**From:** [Roakes, Raymond A. - PDR](#)  
**To:** [Trump, Shaianna L. - PDR](#)  
**Subject:** FW: Mayo Bridge Design and Manchester Canal Bridge  
**Date:** Tuesday, January 20, 2026 9:49:04 AM

**From:** CHARLES WARE <[stclairware@comcast.net](mailto:stclairware@comcast.net)>  
**Sent:** Sunday, January 18, 2026 10:57 PM  
**To:** Kim, John S. - DPW <[John.Kim@rva.gov](mailto:John.Kim@rva.gov)>; Roakes, Raymond A. - PDR <[Raymond.Roakes@rva.gov](mailto:Raymond.Roakes@rva.gov)>; Robins, Amy E. - City Council Office <[Amy.Robins@rva.gov](mailto:Amy.Robins@rva.gov)>; [velzyg@verizon.net](mailto:velzyg@verizon.net)  
**Subject:** Mayo Bridge Design and Manchester Canal Bridge

UDC 2026-01

**From:** Janet Woodka <jlwoodka@mac.com>  
**Sent:** Wednesday, January 14, 2026 10:15 AM  
**To:** Roakes, Raymond A. - PDR  
**Cc:** sgrice@smbw.com  
**Subject:** Mayo Bridge - UDC conceptual review - comments from Manchester Alliance and Shockoe Partnership

# Mayo Bridge with Bike Lane Barrier

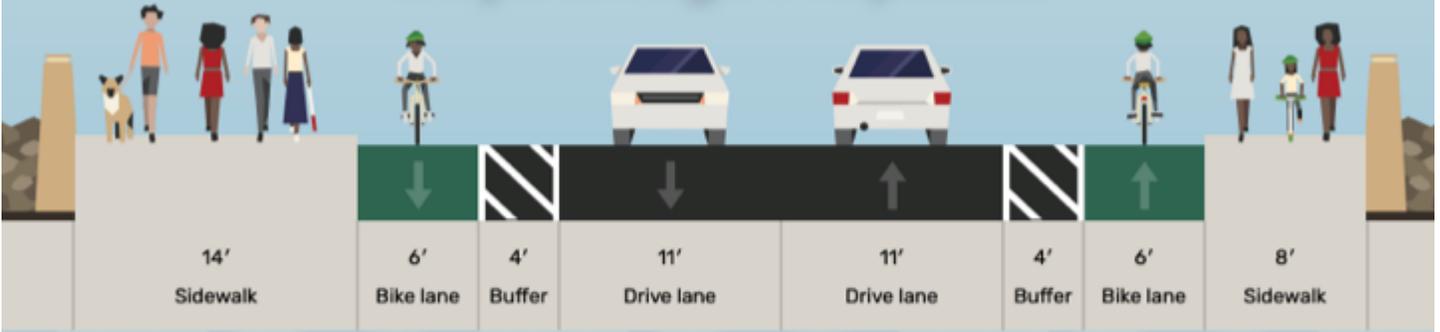
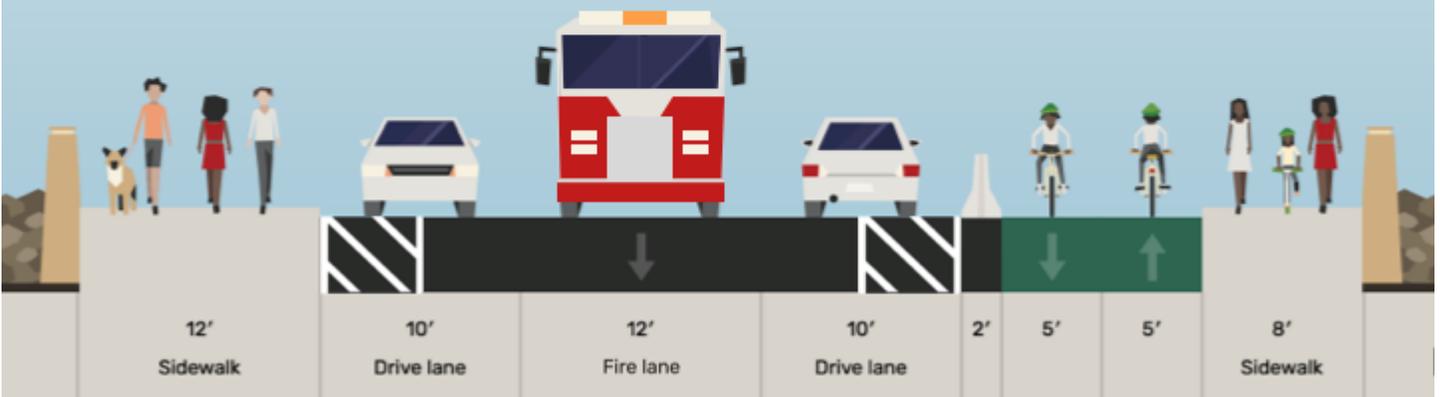
The Mayo Bridge could easily have barriers for the bike lanes by combining two lanes on one side, reducing the bike lane widths to 5 ft each (Capital Trail is 10 feet), and reducing the western sidewalk to 12 feet.
